ADDENDUM NO. 08

Date of Addendum: 4-11-14

PROJECT NAME: TIGER Project #1 – White Oak Path:
Alabonson Rd. to Antoine Dr. Link

PROJECT NO: WBS No. F-TIGER4-0001-4

SHEET NO. 81 OF 122

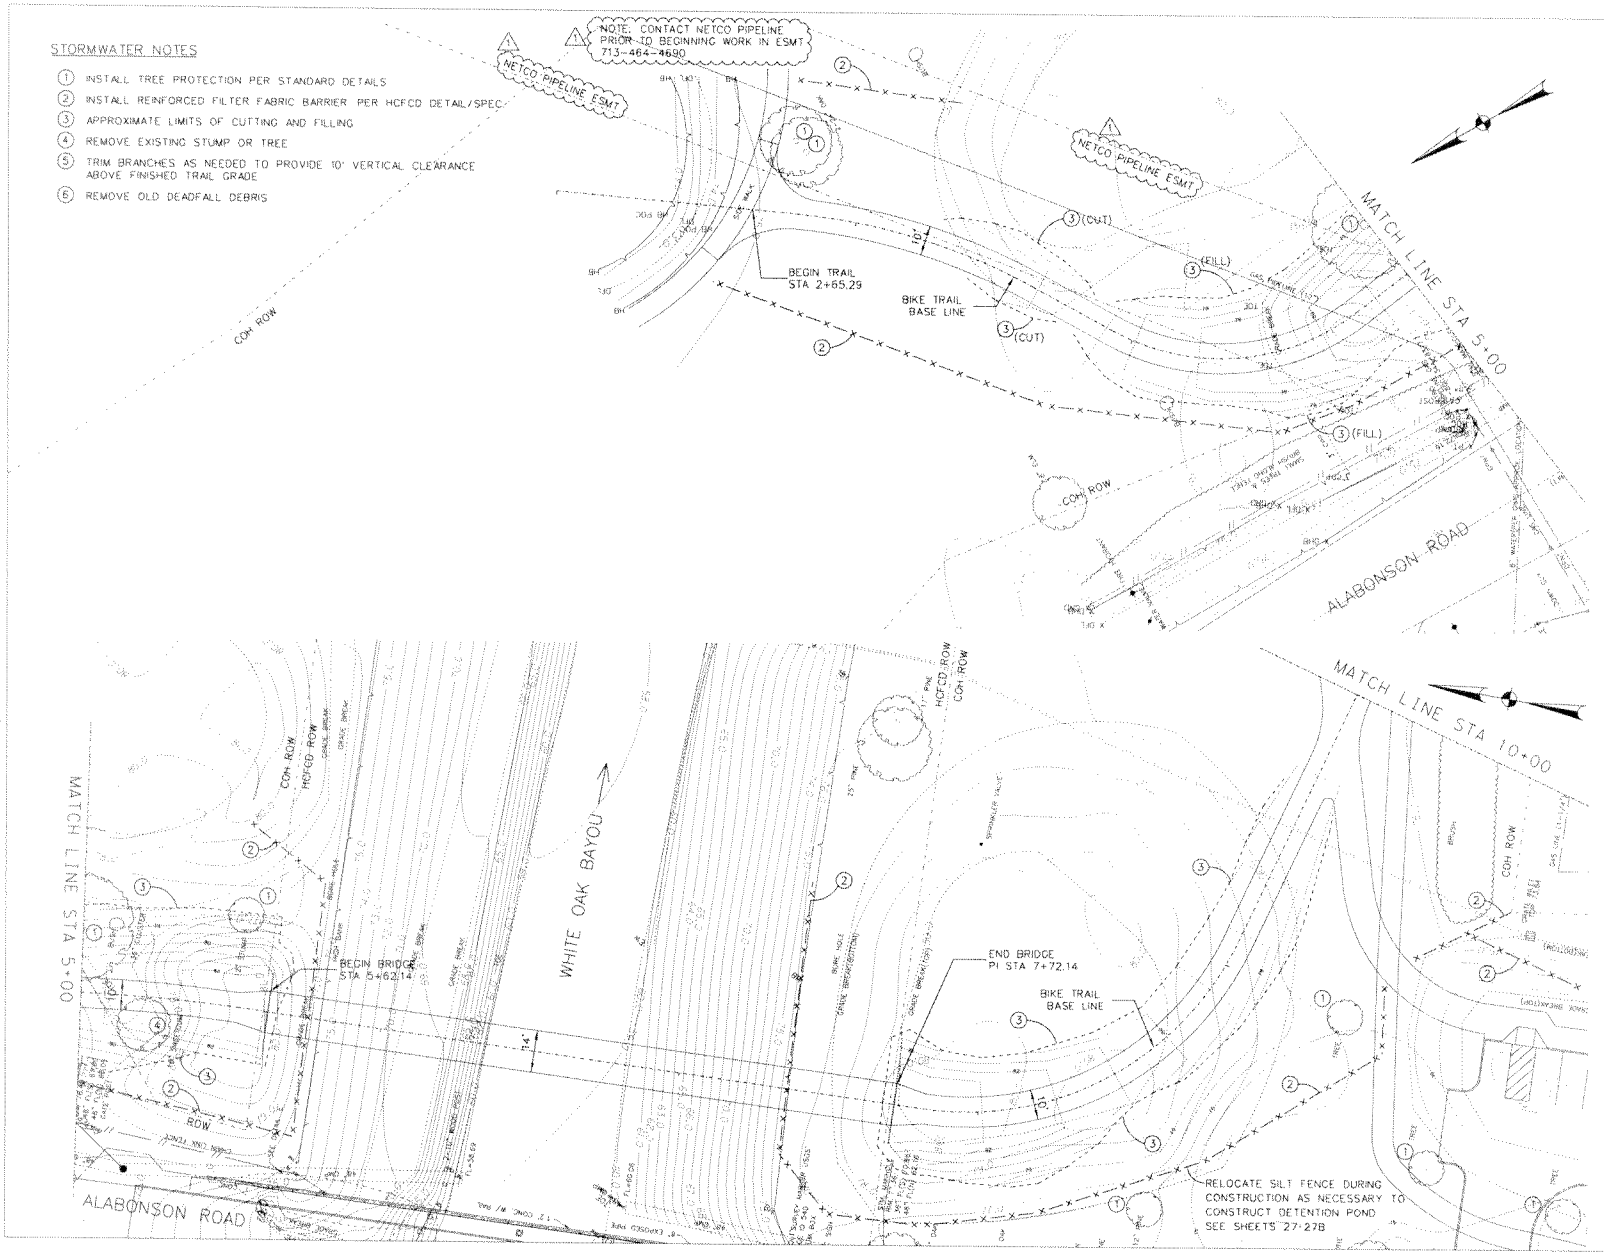
10. Delete Sheet 81, Stormwater Pollution Prevention Plan Sta. 2+00 to 10+00, and replace with attached Sheet 81. Note added that silt fence may be relocated during construction, as necessary to construct detention pond shown on sheets 27-27B.

SHEET NO. 90 OF 122

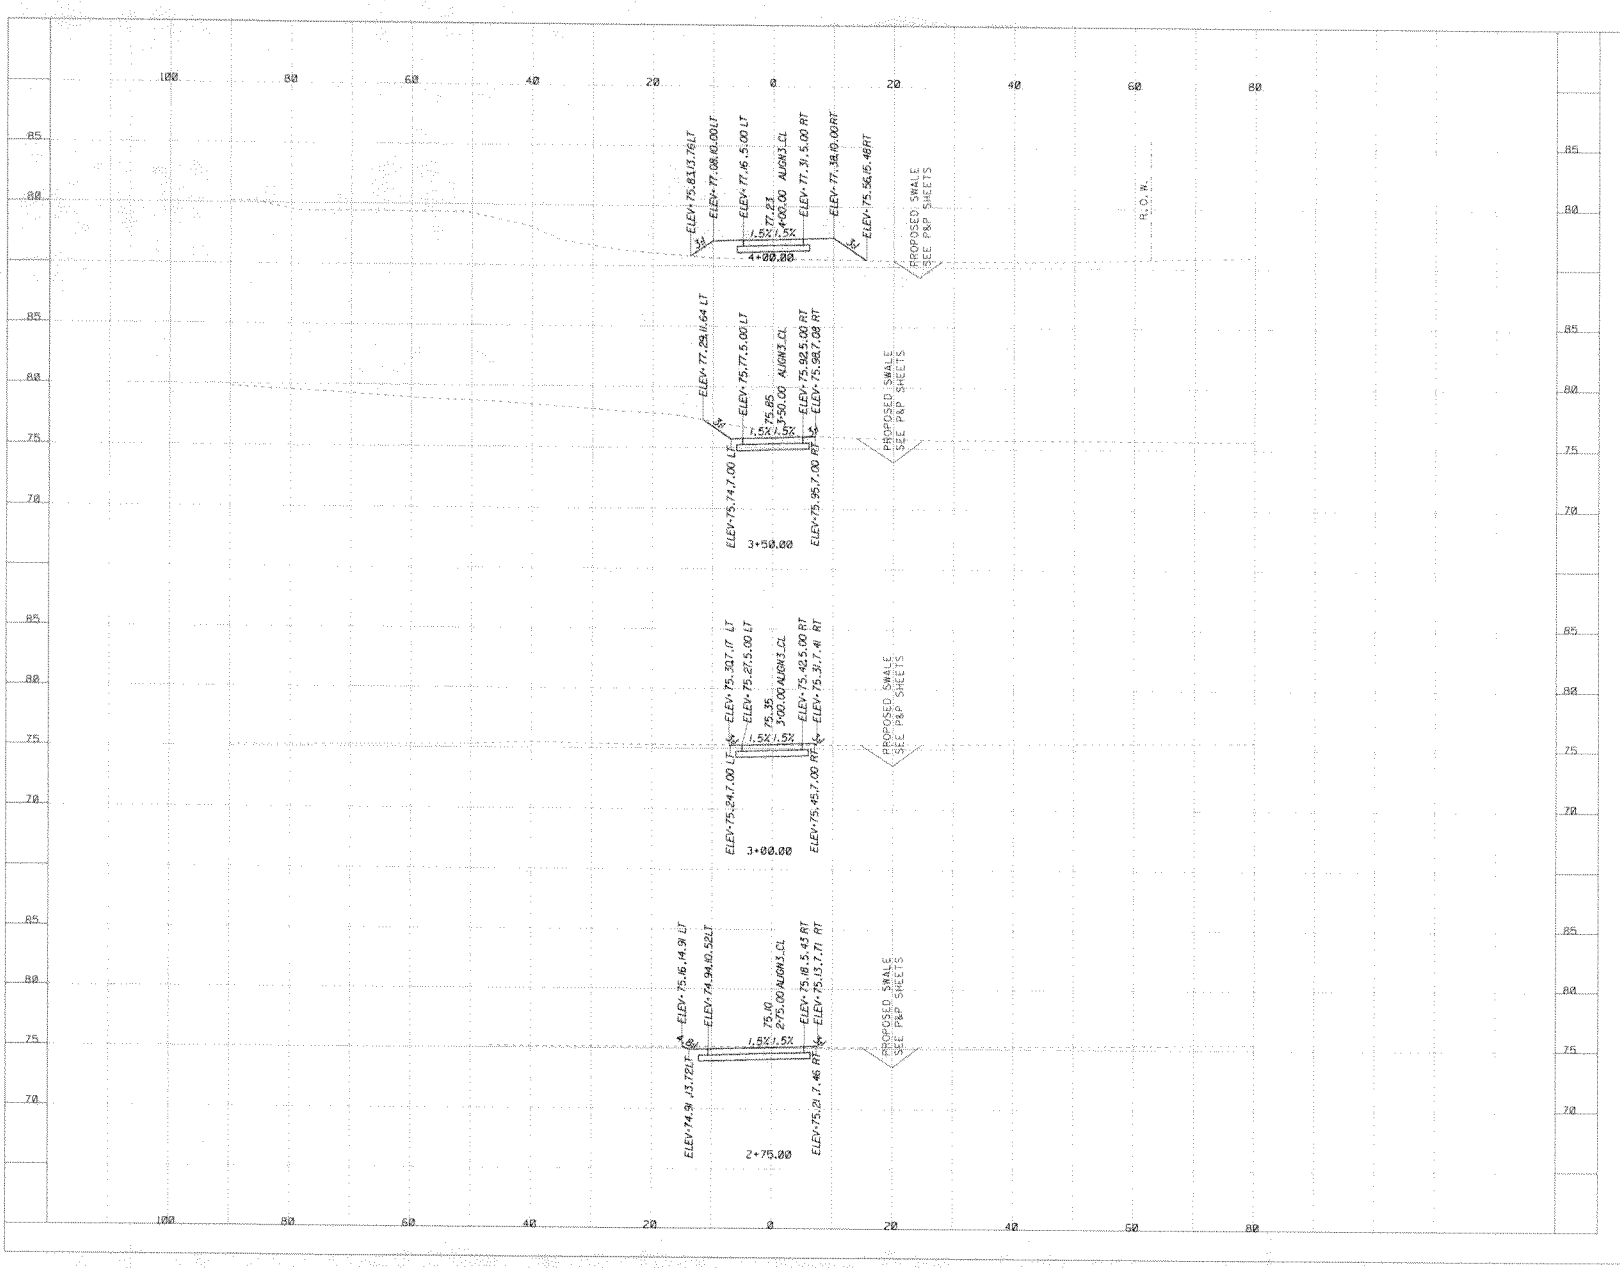
11. Delete Sheet 90, Design Cross Sections Sta. 2+75.00 to Sta. 4+00.00, and replace with attached Sheet 90. Swale has been added to cross-sections, in conjunction with changes to Sheet 18.
